WESTWOOD SHOPPING CENTER
SITE PLAN AMENDMENT NO. 82018019A

The Applicant proposes to modify a previously approved multifamily building to reduce the ground floor commercial use by 18,792 square feet, redesign the original below-grade parking to entirely above-grade parking that the multifamily units will wrap, modify building elevations and changes to location of transformers, loading, and garage access.

PLANNING BOARD HEARING DATE: 5/15/2025

Figure 5 – Illustrative Site Plan No. 820180190A

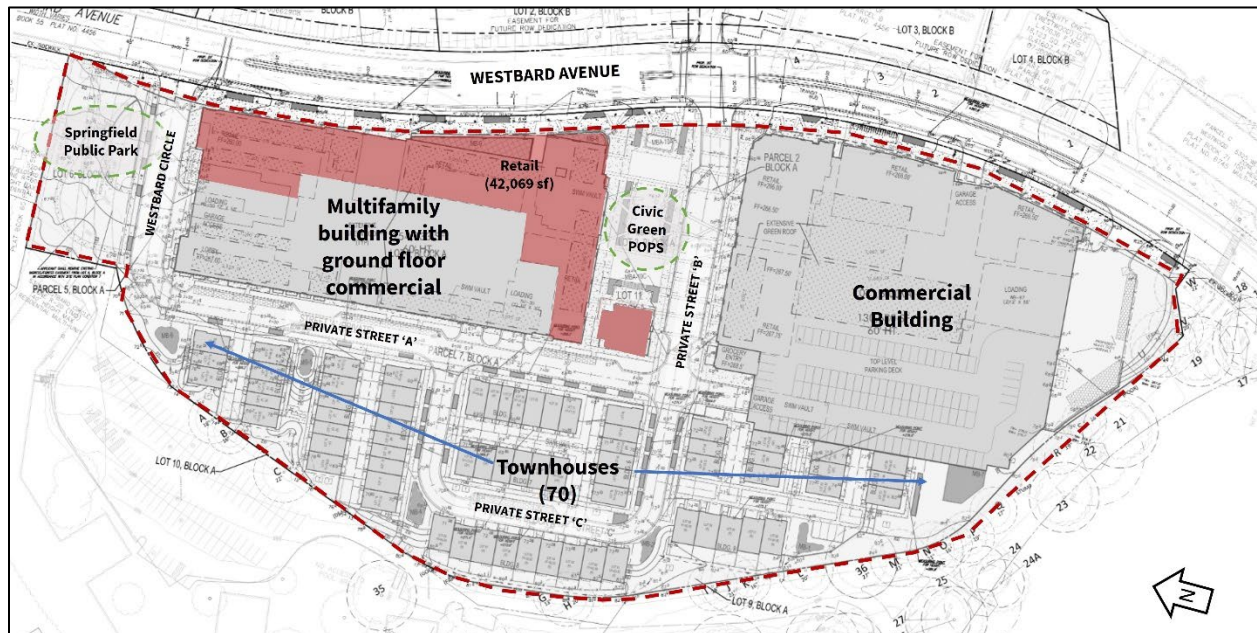
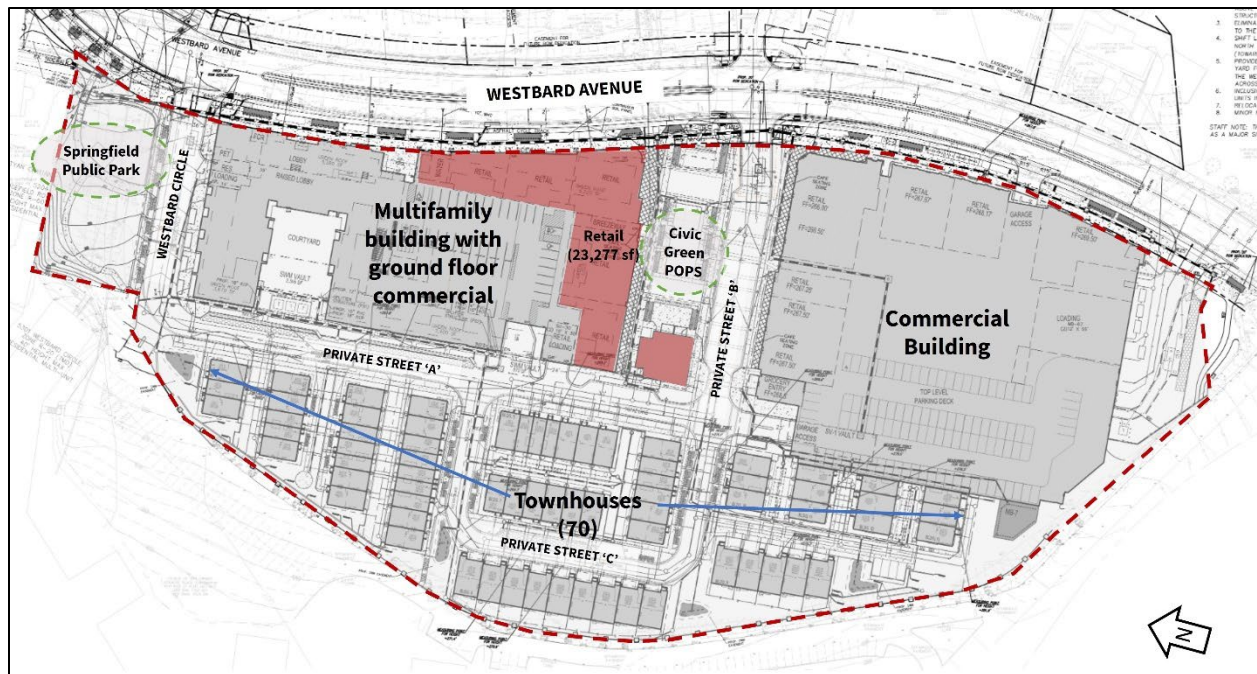
The Applicant proposes to reduce the amount of commercial space on the ground floor of the multifamily building by 18,792 square feet (for a maximum of 23,277 square feet of commercial), relocate the multifamily building's structured parking from partially below-grade to entirely above-grade, with the multifamily units and ground floor commercial wrapping the above-grade parking levels, and update the exterior elevations of the building due to the programming changes.

Figure 6 –Site Plan No. 820180190A proposed elevation changes for Multifamily building

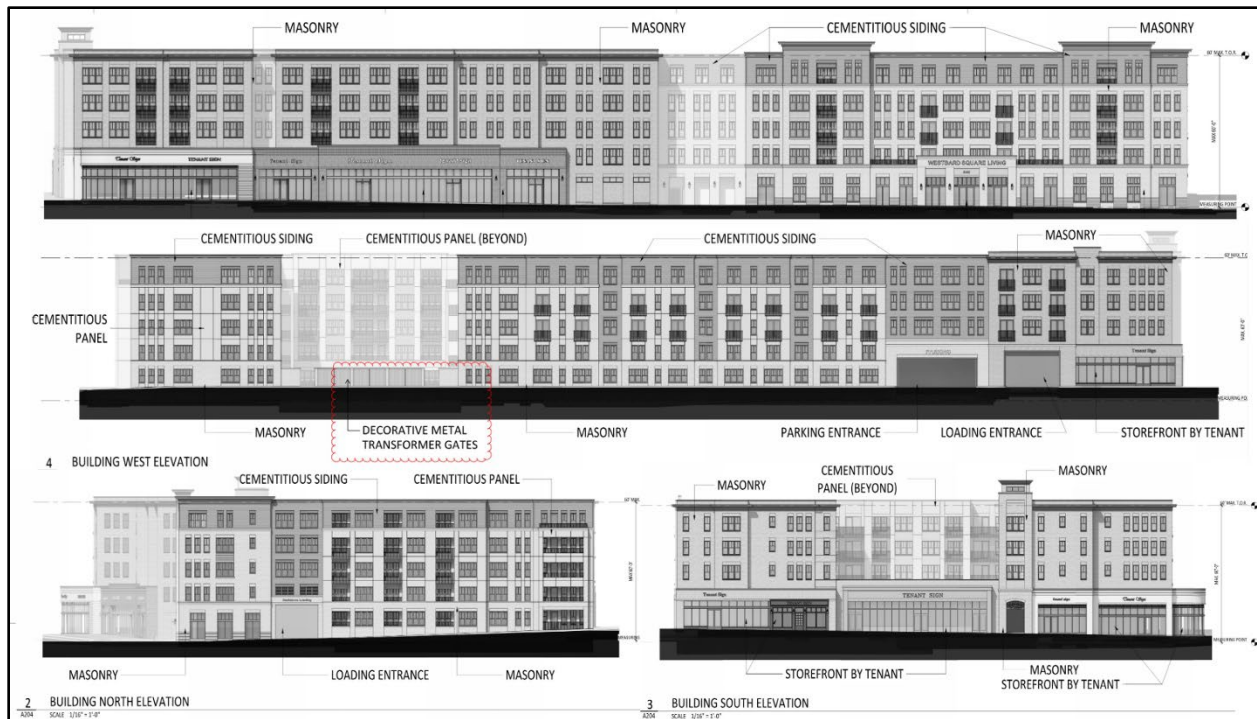
The proposed programming changes within the Multifamily building will result in exterior changes to the elevations. This includes removal of the ground floor retail fronting Westbard Avenue at the corner of Westbard Circle, which is now proposed as the residential lobby. The remaining retail will continue to front on Westbard Avenue towards Private Street B and the Civic Green. The one-story retail building within the Civic Green remains unchanged with this Amendment. The Amendment also introduces a ground floor courtyard for the residents of the multifamily building, with two entrances from Private Street A, and relocates the transformers to line the street. The Applicant proposes to screen the transformers with decorative metal screening. At the base, the building has been designed with large retail storefronts, in keeping with the development standards as originally approved for transparency and door spacing. Above the base, the building will maintain a cementitious panel with windows and balconies; these materials and elements are similar to the original approval.

Figure 7 – Circulation Exhibit for Site Plan No. 82018019A

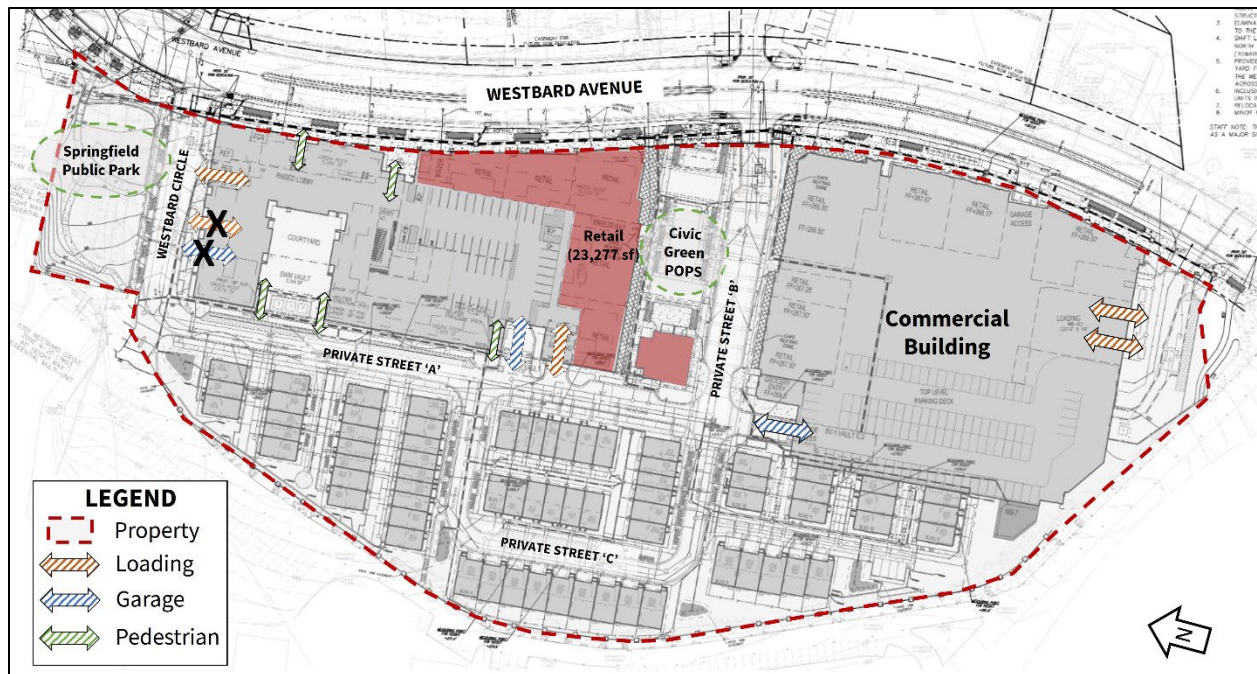
No major changes are proposed to the previously approved street sections, streetscape, or public right-of-way. The Amendment proposes to relocate the garage access from Westbard Circle to Private Street A and to shift the loading on Westbard Circle closer to Westbard Avenue.

The Project was originally approved with two separate garage access points, one for the retail and one for the multifamily units. The Amendment will consolidate the garage access for the multifamily portion of the building from Westbard Circle to utilize the same garage access point for the retail on Private Street 'A'. The Amendment maintains two separate loading bays, one for the retail and one for the multifamily units. The loading for the multifamily units has shifted on Westbard Circle and has been reviewed to ensure safe and adequate turning movements into and out of the building and allow adequate space for loading activities within the building.
